**RELEASED FOR
CONSTRUCTION**
As Noted on Plans Review

Development Services Department
Lee's Summit, Missouri
06/20/2024

PROJECT TITLE:
SUITES

DRAWING TITLE:
PROPOSED FLOOR PLAN

PROPOSED FLOOR PLAN
AR 01 SCALE 3/16"=1'-0"

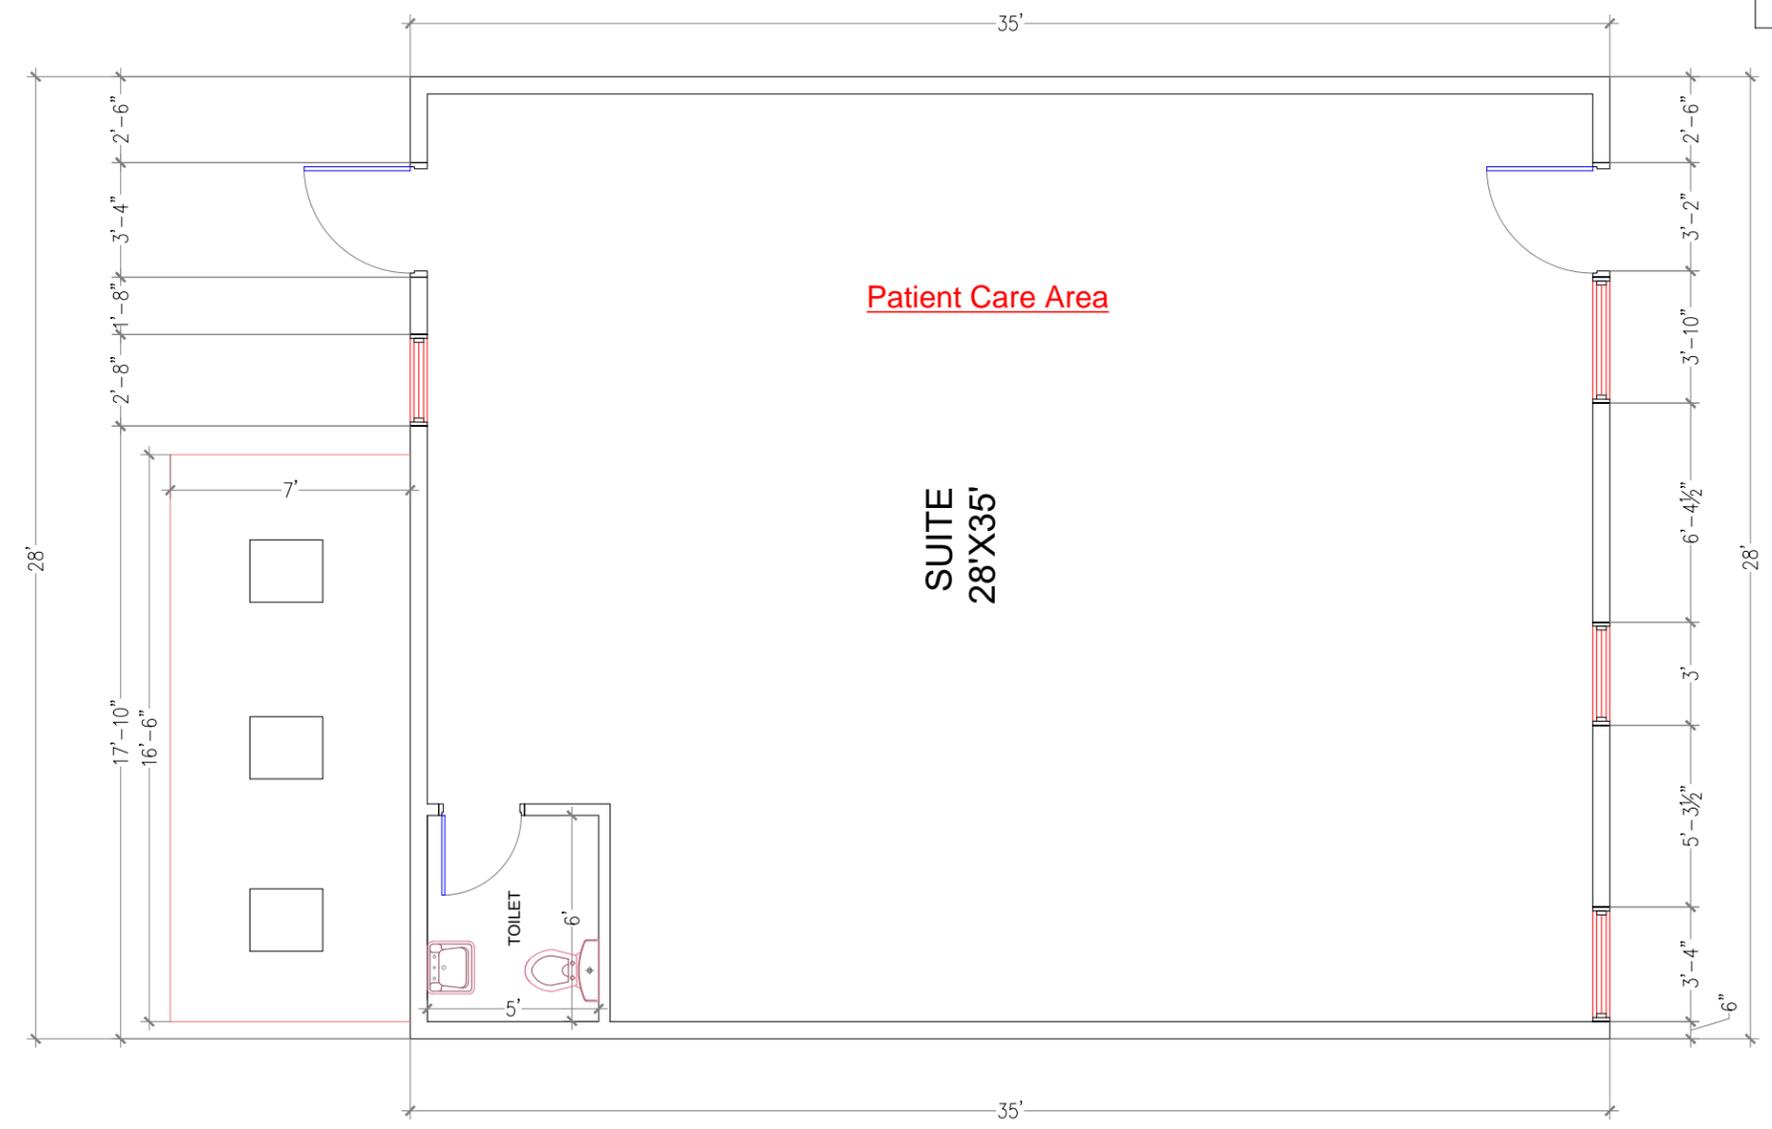
All electrical in patient care area to have redundant ground per 2017 NEC Article 517.13
